**NFPA 79 Technical Committee on Electrical Equipment of Industrial Machinery
First Draft Meeting Agenda (F2020)
March 4 – 8, 2019
Hampton Inn & Suites Savannah Historic District
Savannah, GA**

Attachment D: NFPA 79 Public Input Report

Public Input No. 102-NFPA 79-2019 [Global Input]

Figure 6.2.3 Jointed Test Finger.

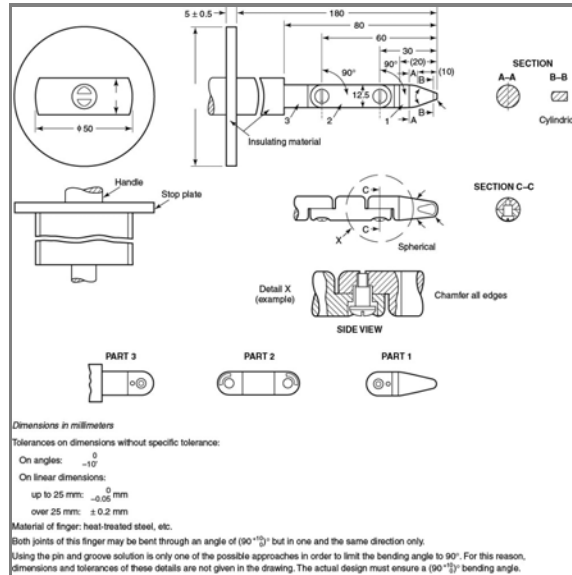
The current Figure 6.2.3 is missing critical dimensions which permits a person to reproduce the probe. The attached image shows the probe with the missing data to be used to correct the figure.

Figure 6.2.3 Jointed Test Finger.

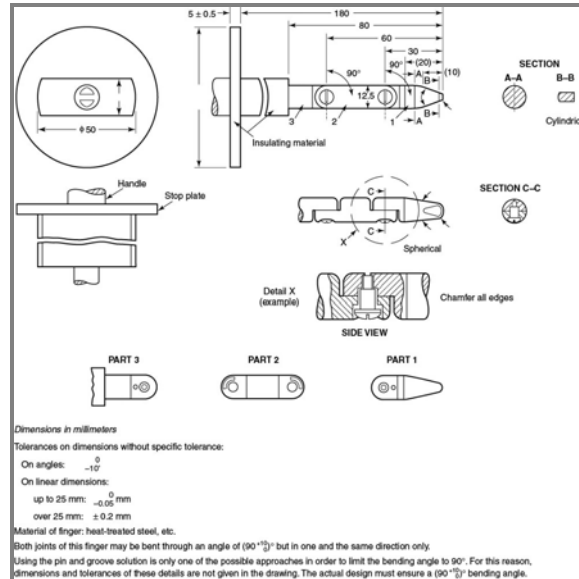
Equipment enclosures and enclosure openings shall, enclosure openings, and viewing windows shall meet the requirements of UL 508, UL 508A, UL 50, or NEMA 250. (See Figure 6.2.3.)

NFPA 79. article 8.3.2

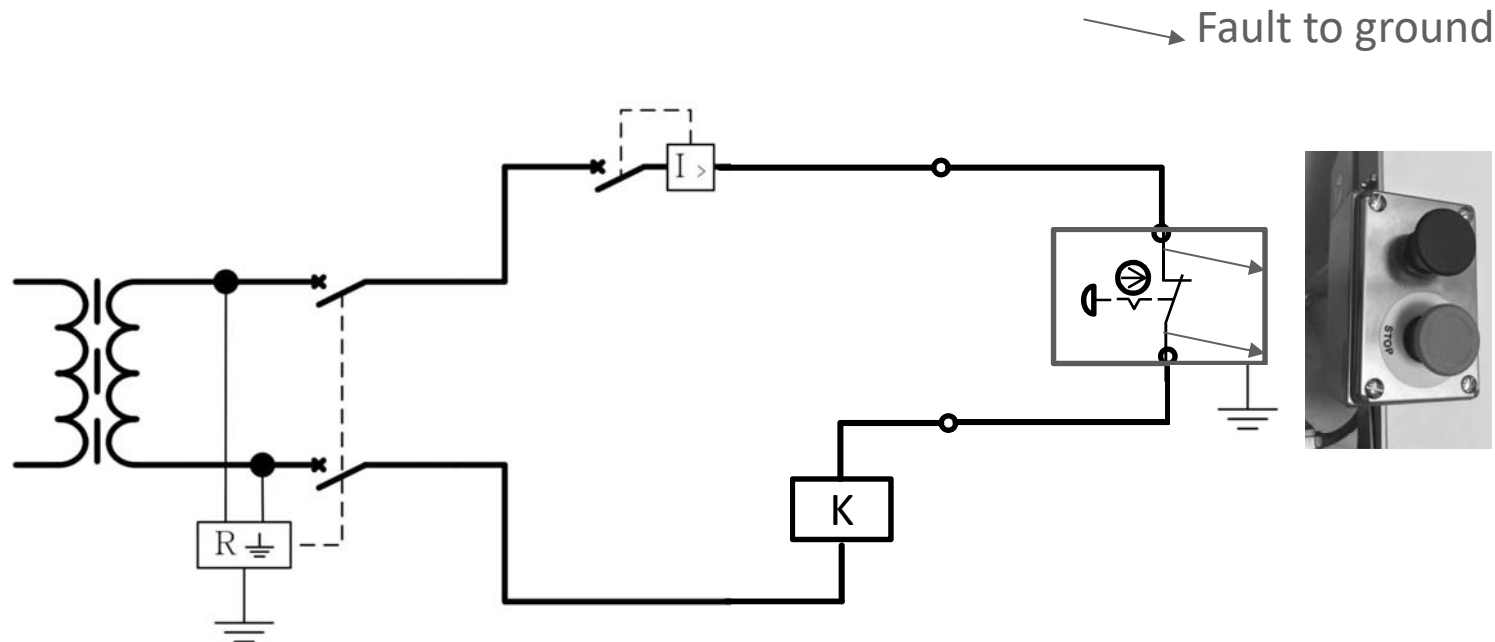
In case of a double fault to ground inside the emergency box, the emergency pushbutton becomes inactive even in case it is activated.

In order to avoid that risk, an insulation monitoring is always needed

Exception: Class 2 low-voltage circuits in Article 725 of NFPA 70 shall not require insulation monitoring. delete note

Figure A.4.5.2(a) Symbol that Represents Functional Equipotential Bonding — IEC Symbol Number 5020.

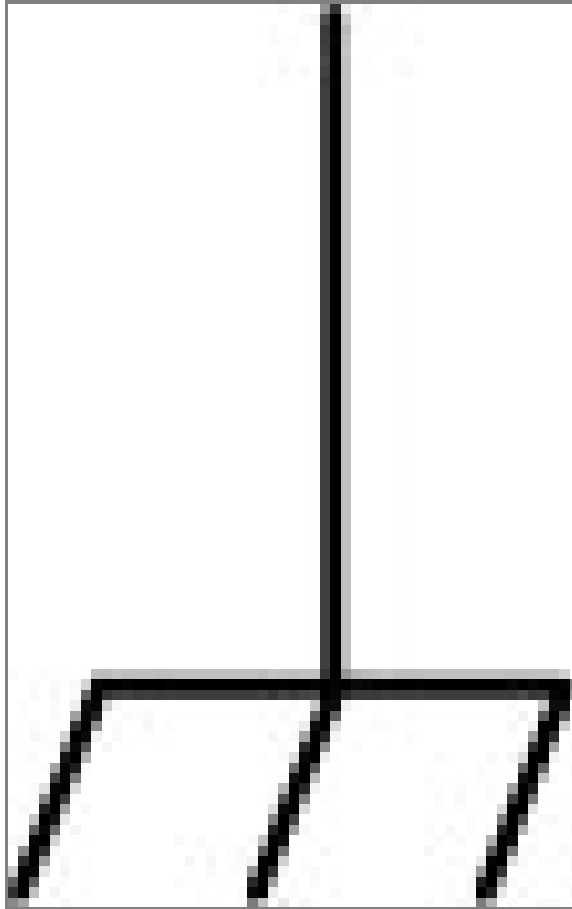
- (12) Connection of sensitive electrical circuits to the chassis. Such terminations should be marked or labeled with the IEC Symbol 5020 from IEC 60417-1. [See Figure A.4.5.2(a) .]

Figure A.4.5.2(b) Symbol that Represents Functional Earthing — IEC Symbol Number 5018.

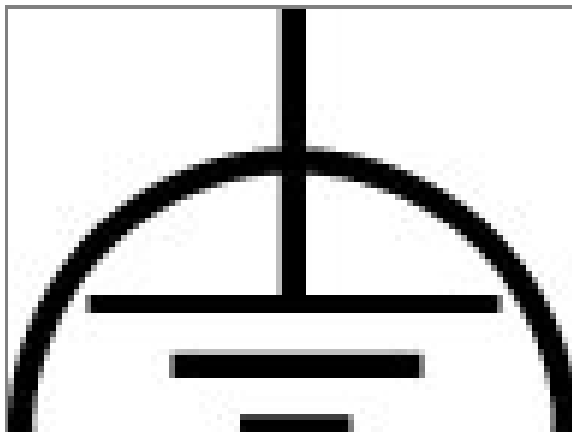
- (13) Connection of the chassis to earth (PE) using a conductor with low RF impedance and as short as practicable.
 - (14) Connection of sensitive electrical equipment or circuits directly to the PE circuit or to a functional earthing conductor (FE), to minimize common mode disturbance. This latter terminal should be marked or labeled with the IEC Symbol 5018 from IEC 60417. [See Figure A.4.5.2(b) .]
